Staff Report

Re: The Twenty Ones – Design Review & Special Exception Petitions PLNPCM2019-01170 & PLNPCM2020-00200

Design Review & Special Exception

Property Address: Approximately 2105 East 2100 South
Parcel IDs: 16-22-103-001, 16-22-103-002, 16-22-103-003, 16-22-103-007, 16-22-103-008, 16-22-103-010, 16-22-103-011, 16-15-359-014, 16-15-359-015, 16-15-359-016
Zoning District: CB (Community Business)
Master Plan: Sugar House – 21st and 21st Neighborhood Plan

Revised 2100 South façade with callout of some changes to the design.

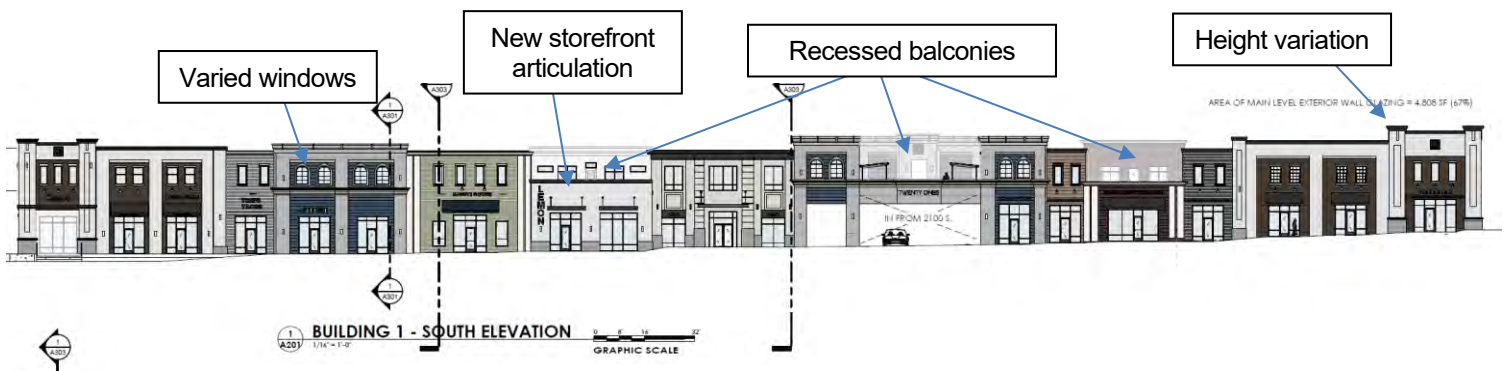
The proposed length of the 2100 South street facing façade is approximately 460 feet. Although the CB zone does not have a design standard related to the maximum length of a street-facing façade, the 21st and 21st Neighborhood Plan provides guidance, stating that the length of a street-facing façade should not be longer than 150 feet. Given that the façade is significantly longer than 150 feet, staff had initial concerns with the articulation and breakup of the façade to give the appearance of multiple smaller buildings.

The revised façade appears to be accomplishing the CB zone compatibility standards by varying the roof lines, color and materials, and window size and massing which are considered to be human scale. Further, the addition of the recessed balconies creates the sense of a reduced building height, and greater interest to the pedestrian. Additionally, the proposed bridge now includes a recessed balcony which visually breaks the buildings and is more appropriate to the pedestrian scale.

A100

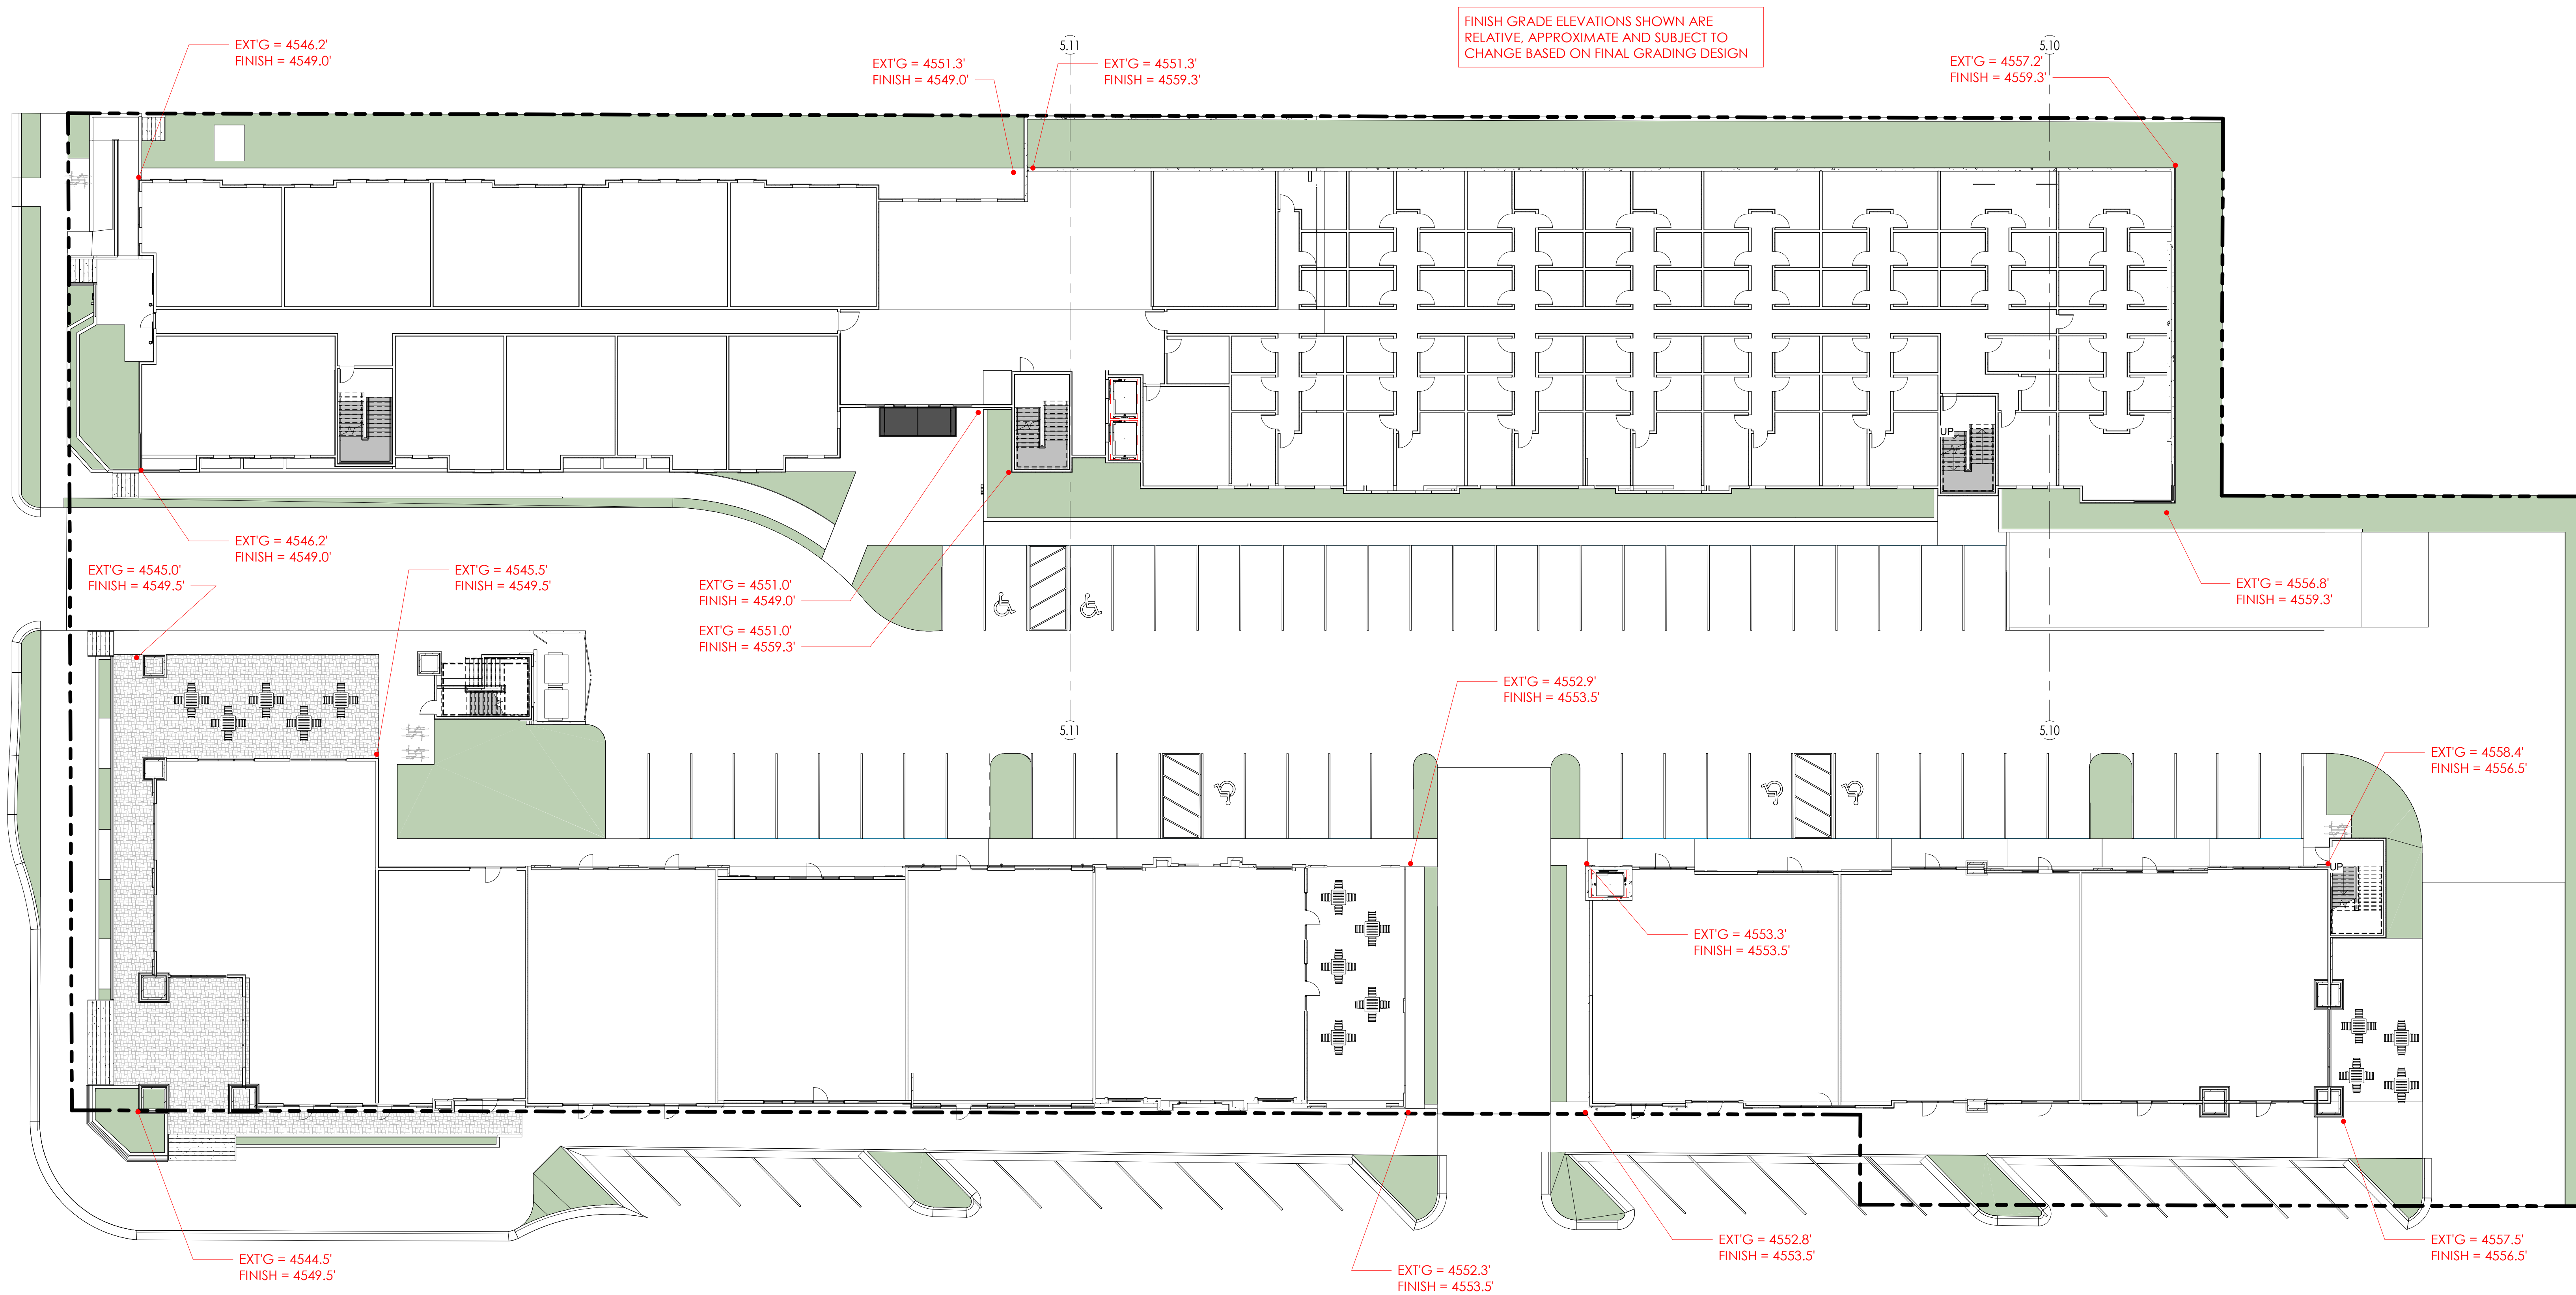
The existing angle parking on 2100 S has an island with a Reduced Speed School Zone flasher which needs to be preserved; the proposed angle parking eliminates the island. Also, the angle parking has many stalls in a row which is more than transportation is comfortable with; an island would be beneficial to provide for signage and/or landscaping.

The perpetuation of cut-back parking needs further review by UF and SLC Planning. Before construction of anything in the public way of 2100 South or 2100 East, a detailed plan review must occur with SLC Engineering prior to issuing a Permit to Work in the Public Way.
